# Memorandum

Message Ref: Review of Landscape and Visual Impacts Assessment, and subsequent further information for Far North Solar Farm, 415 Moroa Road, Greytown

Project No: BM220982

Figure 1 Scheme Plan from application

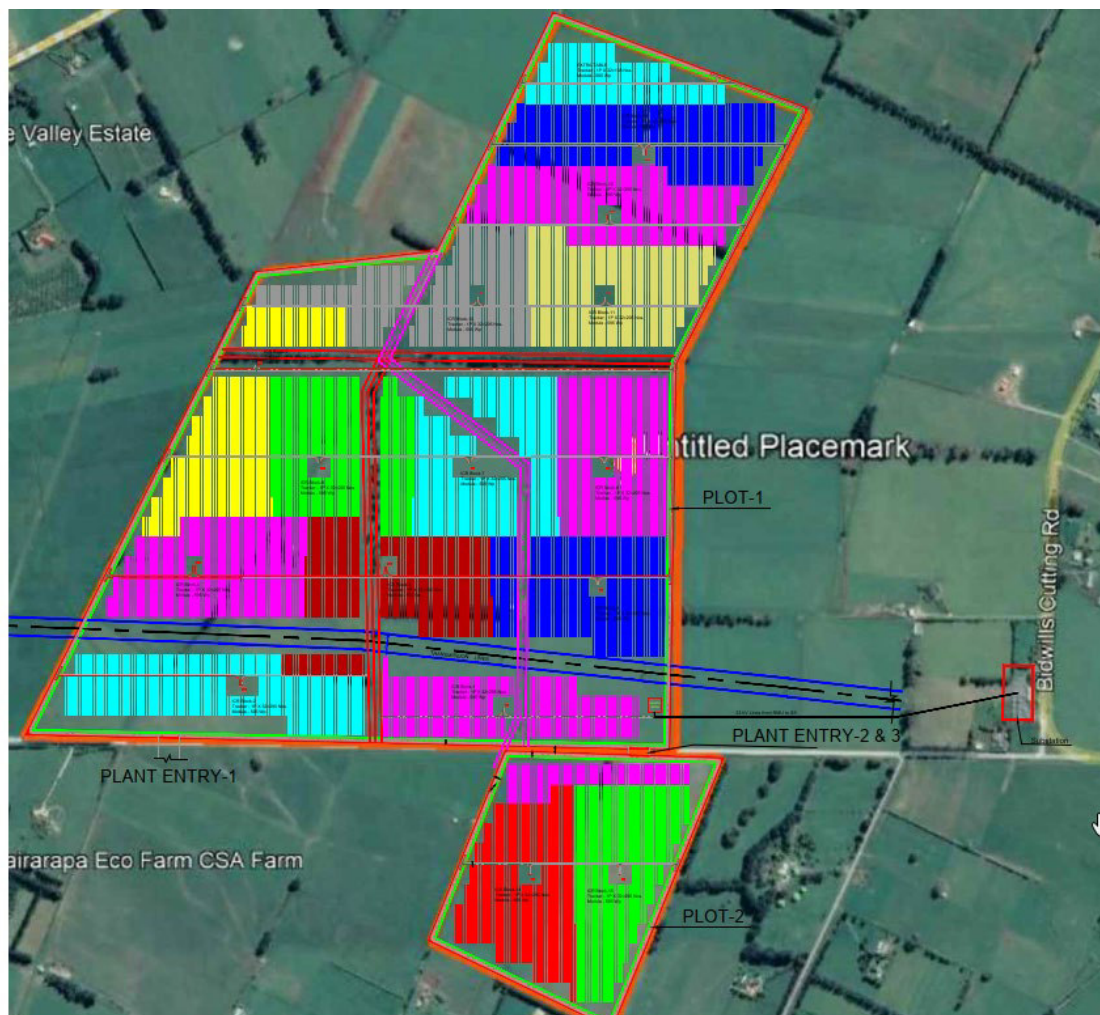
***Advice Note: The existing scheme plan is not approved and will require amending to achieve a compliant design.***
